## Product/Process Change Notification

### < Change of appearance, Power Inductors >

| <b>Date:</b>                             | <b>ID Number (MMDDYY): PCN-072926-MXK</b>                                                                                                                                                                                                                                                                                                                                                                                                                                                                                                                                                                                                         |  |
| <b>Affected Products</b>                 | MPLCH0740 Series.<br>Part Number      Alias<br>MPLCH0740L1R0    UPIF0740L1R000<br>MPLCH0740L1R5    UPIF0740L1R500<br>MPLCH0740L2R2    UPIF0740L2R200<br>MPLCH0740L3R3    UPIF0740L3R300<br>MPLCH0740L4R7    UPIF0740L4R700

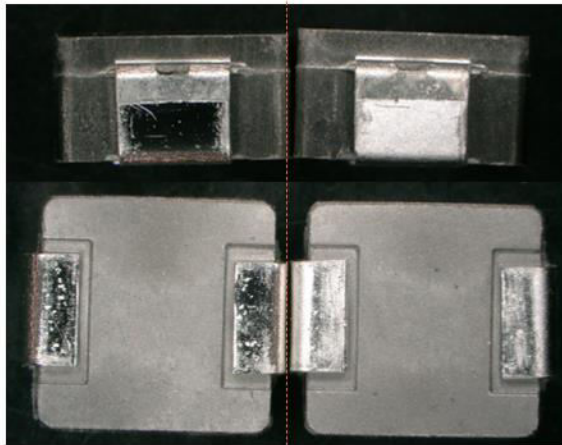
| <b>Change</b>                            | <p>The appearance of the tin plating on the mounting terminals will be changed from a semi-gloss finish to a matte finish.</p> <div style="display: flex; align-items: center;"> <div style="margin-right: 20px;">  <p>Core</p> <p>Winding coil</p> <p>Termination</p> </div> <div> <div style="display: flex; justify-content: space-around; font-size: small;"> <span>Semi-gloss Plating (Current)</span> <span>Matte Plating (After Change)</span> </div>  </div> </div> |  |

| <b>Justification and Benefits</b>        | Due to the discontinuation of a plating material by the current plating supplier. No changes will be made to the terminal/plating supplier, plating material and thickness, inductor manufacturing process, or product specifications.                                                                                                                                                                                                                                                                                                                                                                                                            |  |
